HUNTSVILLE UTILITIES SOUTHEAST WATER TREATMENT PLANT

To: All Plan Holders

From: Tetra Tech

Date: December 10, 2014

D-3302

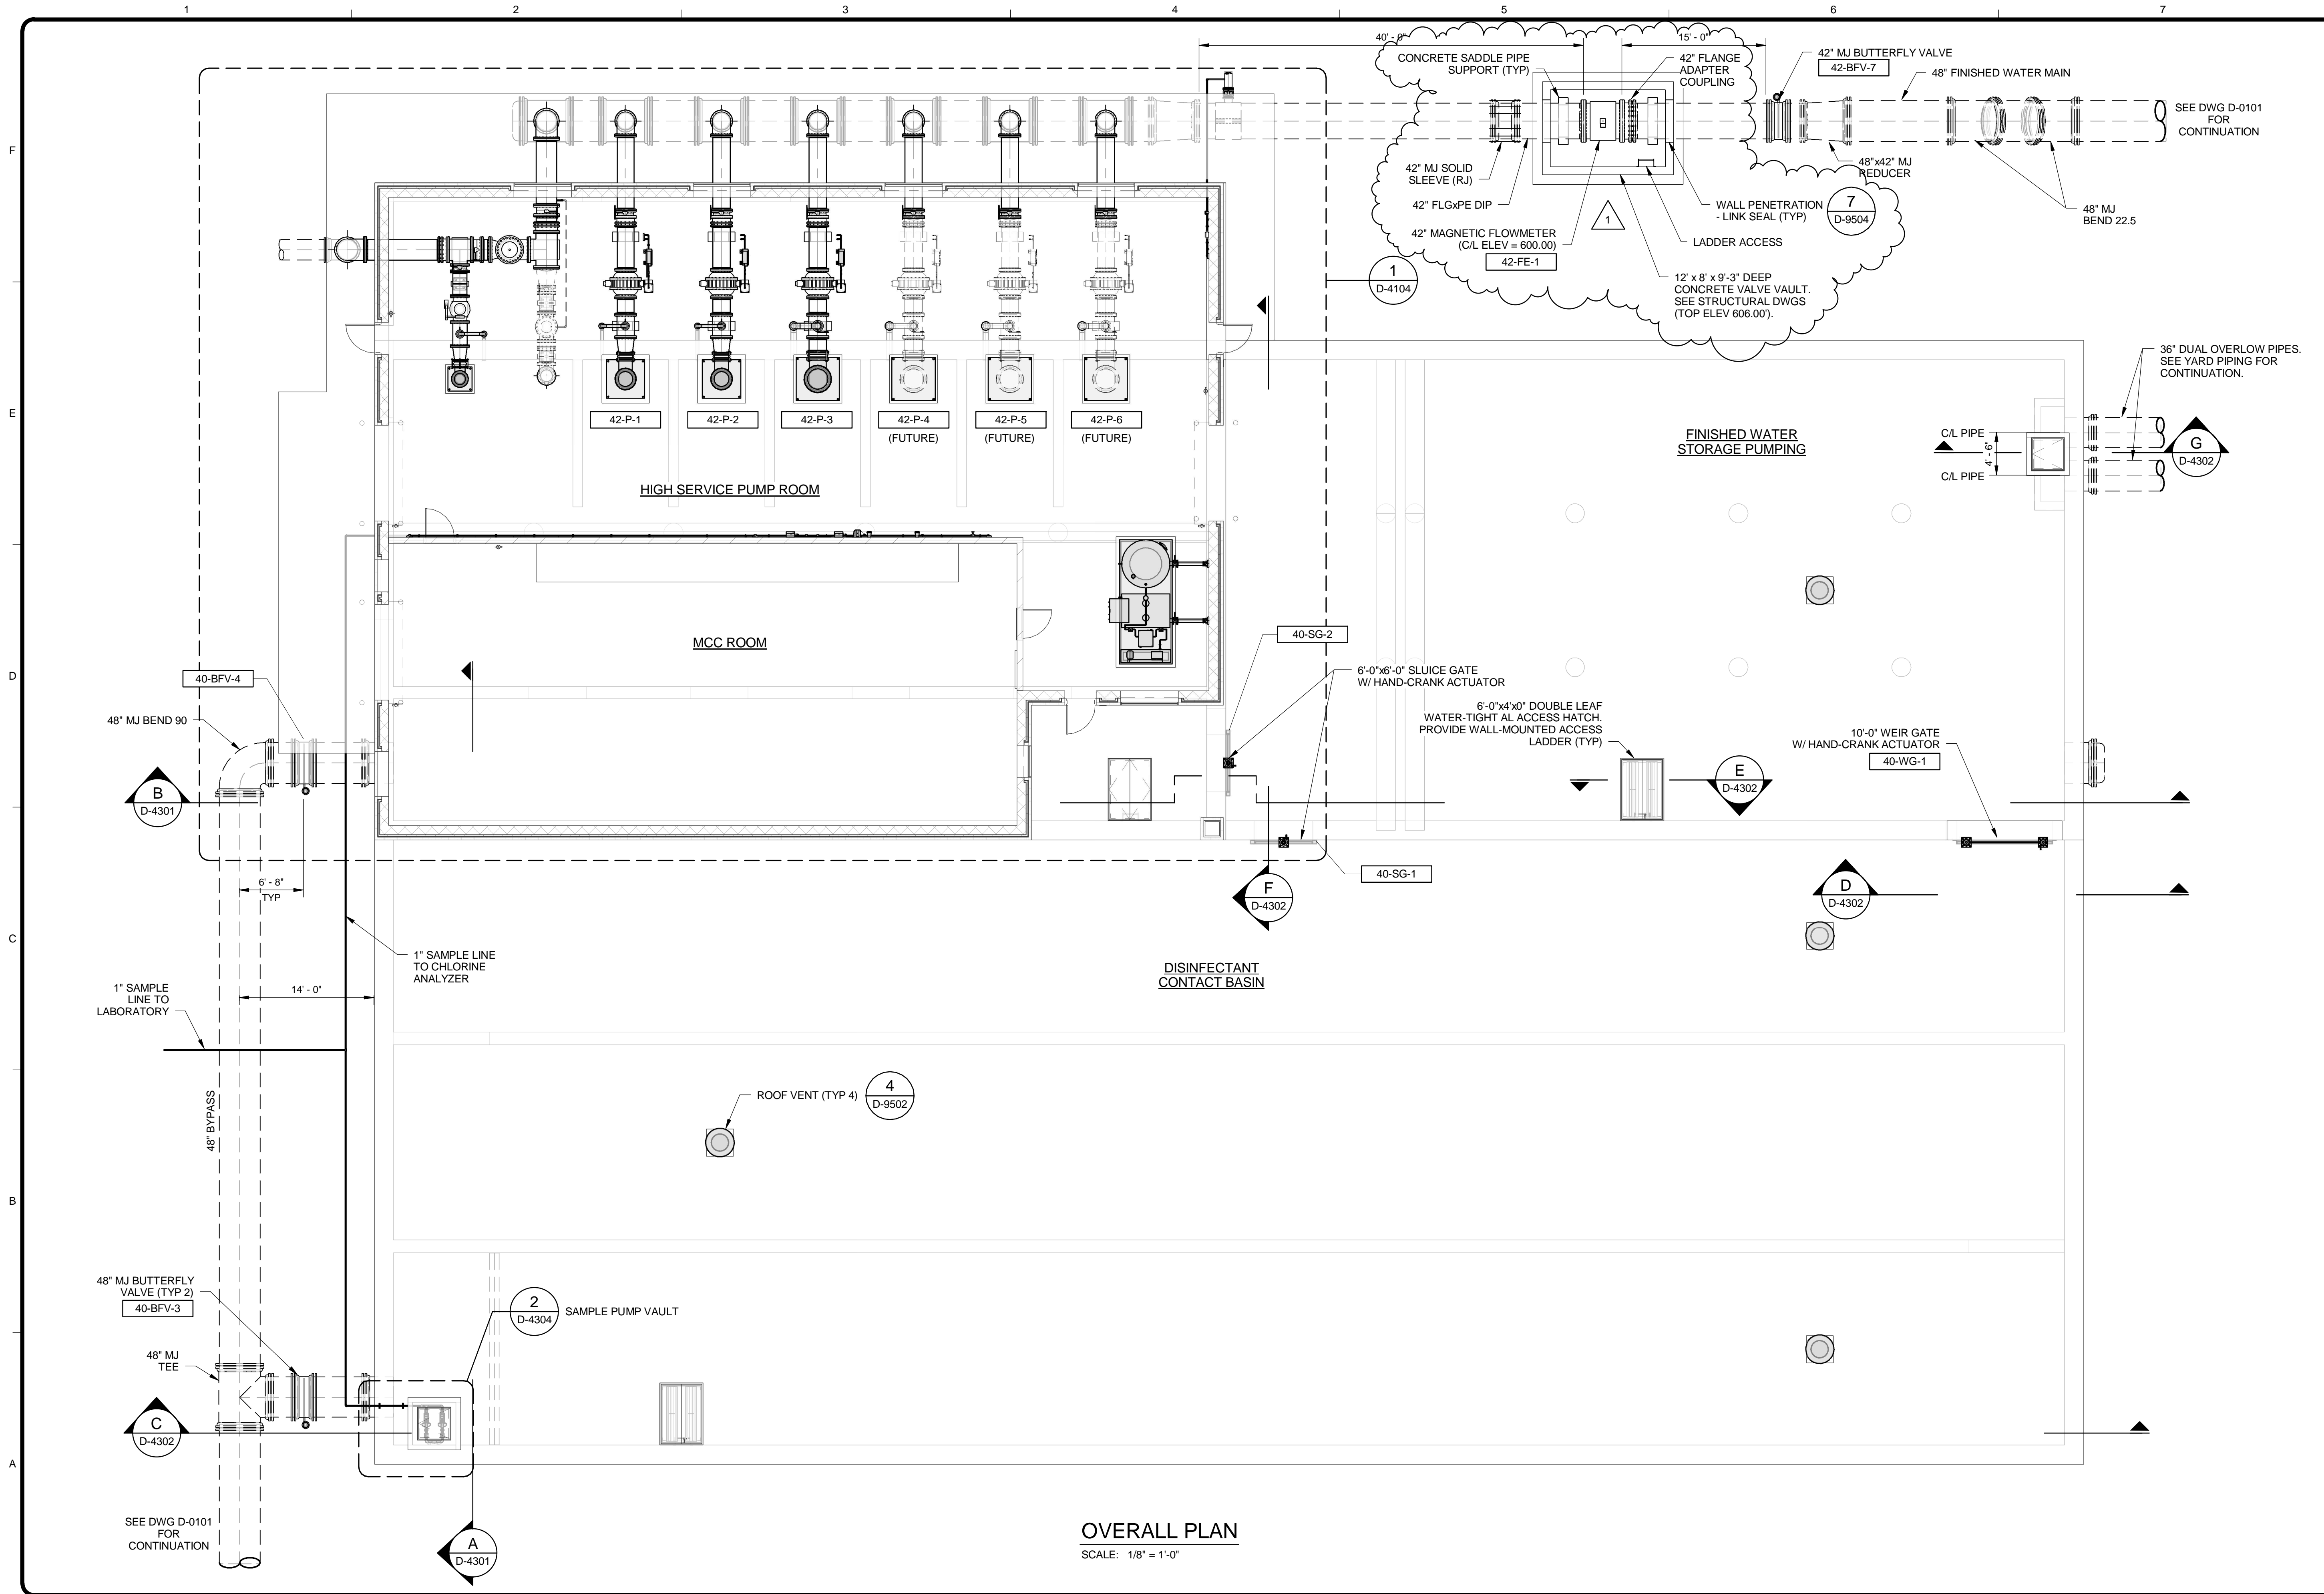
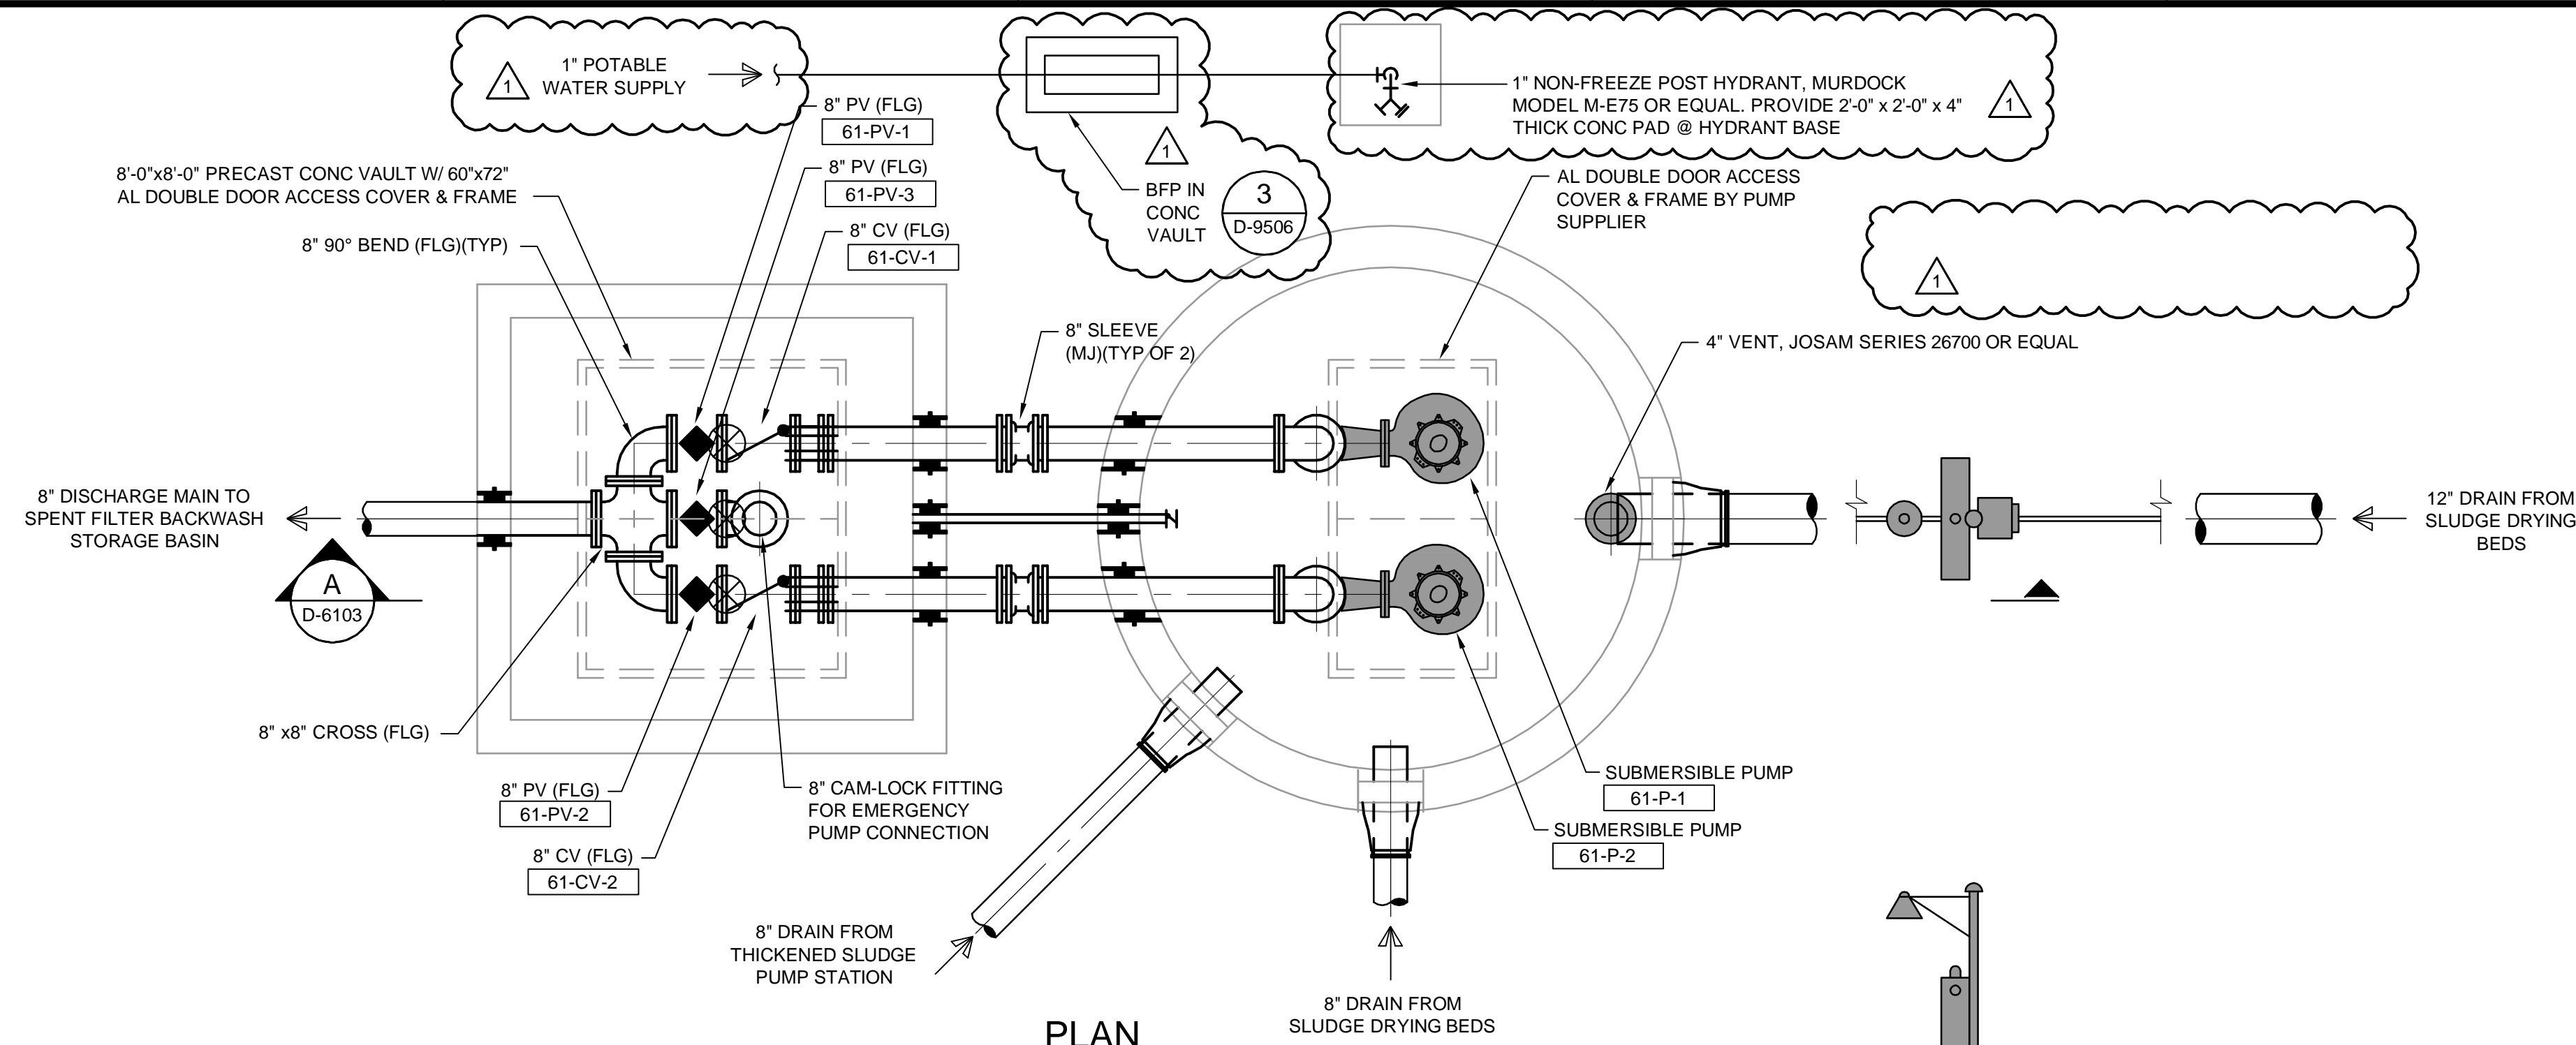
- Item No. 26: **Sheets D-3301 and D-3302.** Replace the existing sheets with revised sheets (attached) noting the requirements for wall pipes with wall collars at each end of the pipe gallery.
